LEWIS HOMEPLACE SUBDIVISION

APPLICATION NUMBER 4 DATE April 15, 2021

REQUEST Subdivision

DETAIL SITE PLAN

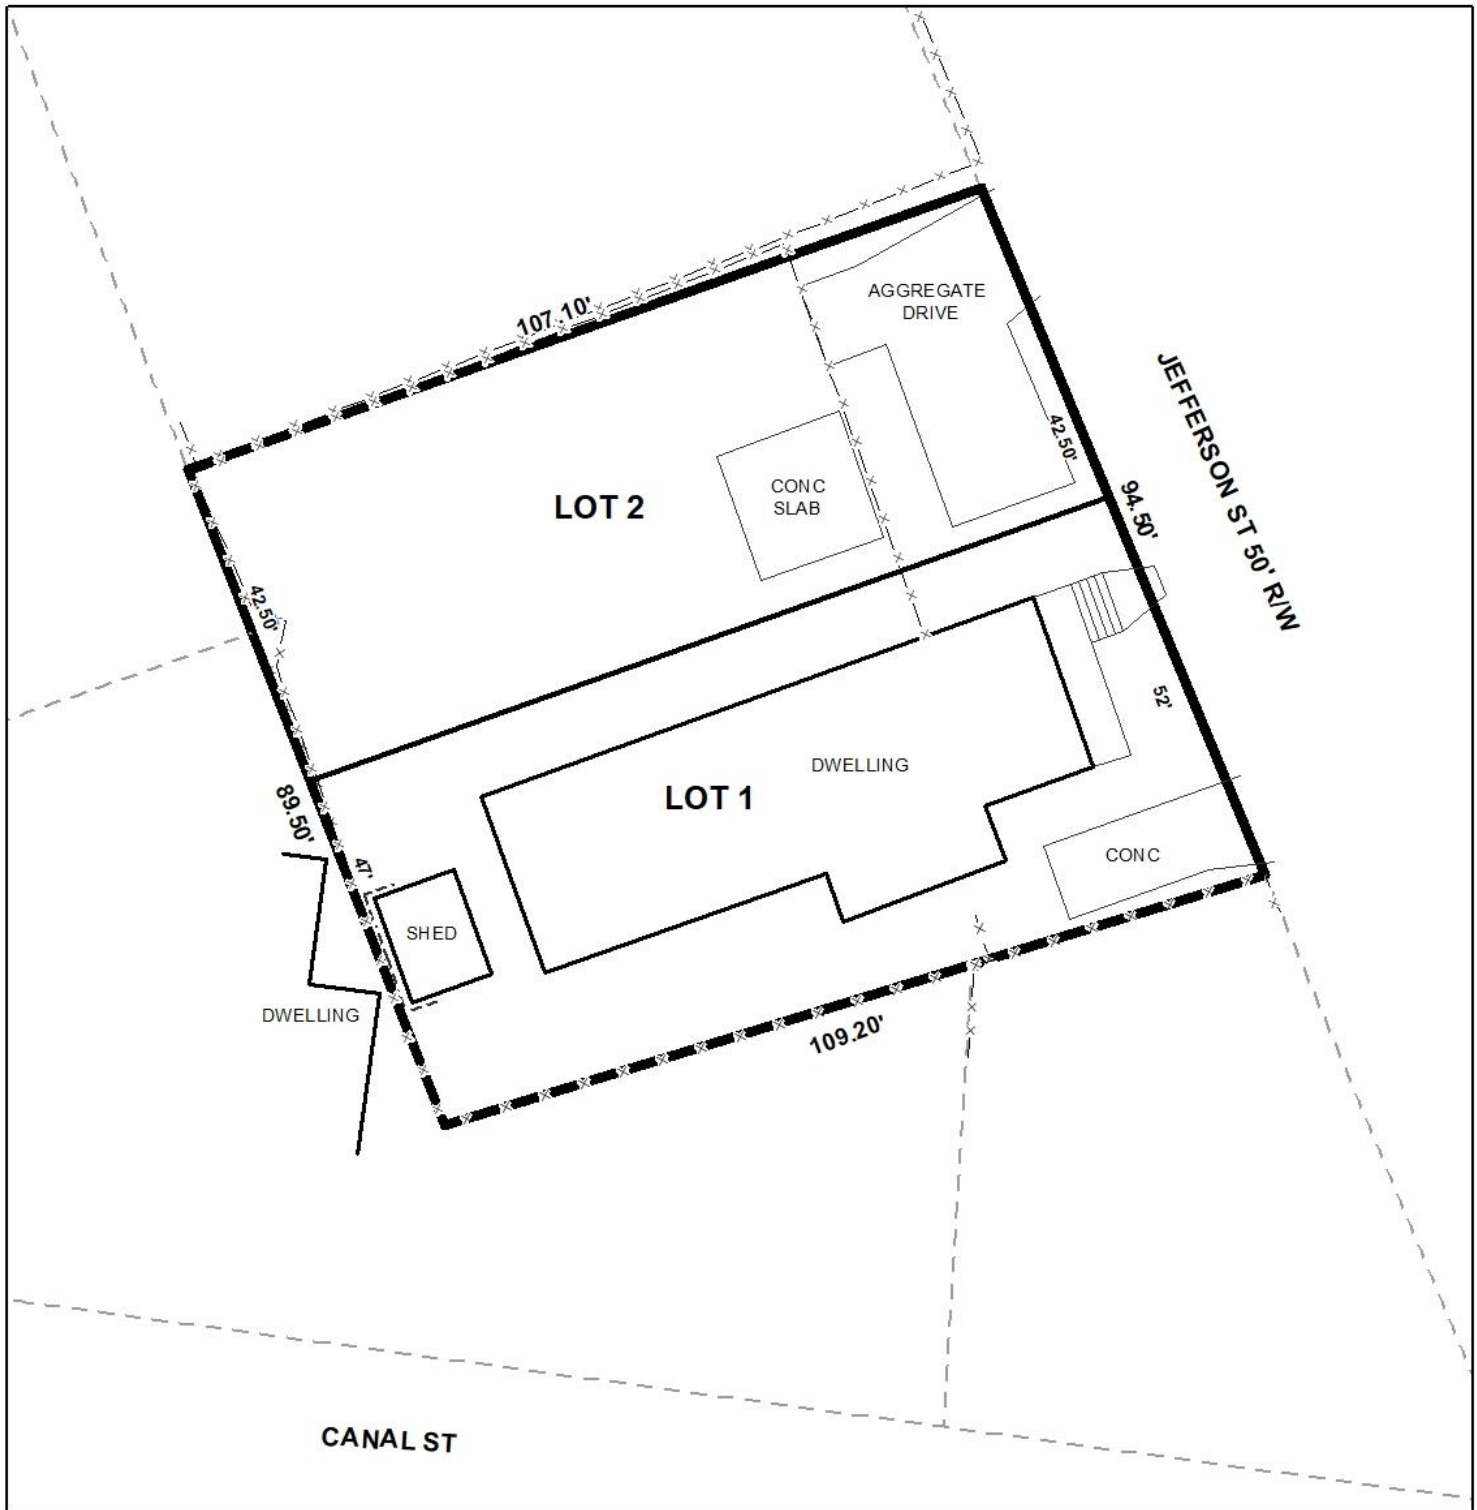
The proposed lots front South Jefferson Street, which is a minor street with curb and gutter and a compliant 50-foot right-of-way. Therefore, no dedication would be required. The right-of-way width should be retained on the Final Plat, if approved.

Property width requirements for a T-3, Low-Density Residential Sub-district, are a minimum of 40 feet and a maximum of 120 feet per Section 64-3.I.8.(b) (1) of the Zoning Ordinance. The proposed lots are within that allowable range, but are less than typically required by Section V.D.2. of the Subdivision Regulations. Therefore, if approved, a waiver of that section will be required.

Per Section 64-3.I.8.(d), the DDD allows from ten-foot minimum to 18-foot maximum setbacks along all street frontages in T-3 Sub-districts. The preliminary plat shows no setback requirements. If approved, the Final Plat should be amended to depict or label a minimum building setback of ten feet and an 18-foot maximum building setback line along South Jefferson Street. As this differs from the standard 25-foot minimum setback required by Section V.D.9. of the Subdivision Regulations, this section will need to be waived, if approved.

The preliminary plat provides the lot sizes in square feet and acres, and if approved, this information should be retained on the Final Plat. As per Section 64-3.I.10.(a), property coverage by all buildings in T-3 Sub-districts shall not exceed 75 percent of the net property area. A note should be required on the Final Plat stating such.

Section 64-3.I.11.(c)(3) limits the driveway width to ten feet within the front setback along primary frontages. A note should be required on the Final Plat stating such. As per the Traffic Engineering comments, each lot is limited to one curb cut with any changes in size, location and design to be approved by Traffic Engineering and conform to AASHTO standards. A note should be required on the Final Plat stating these comments.

- 1) retention of the right-of-way width of South Jefferson Street on the Final Plat;
- 2) revision of the plat to depict or label a minimum setback of ten feet and an 18-foot maximum building setback along South Jefferson Street;

- 3) retention of the lots size labels in both square feet and acres on the Final Plat, or the furnishing of a table on the Final Plat providing the same information;

- 4) placement of a note on the Final Plat stating that site coverage by all structures shall not exceed 75 percent of the net property area;
- 5) placement of a note on the Final Plat stating that driveway width is limited to ten feet within the front setback;
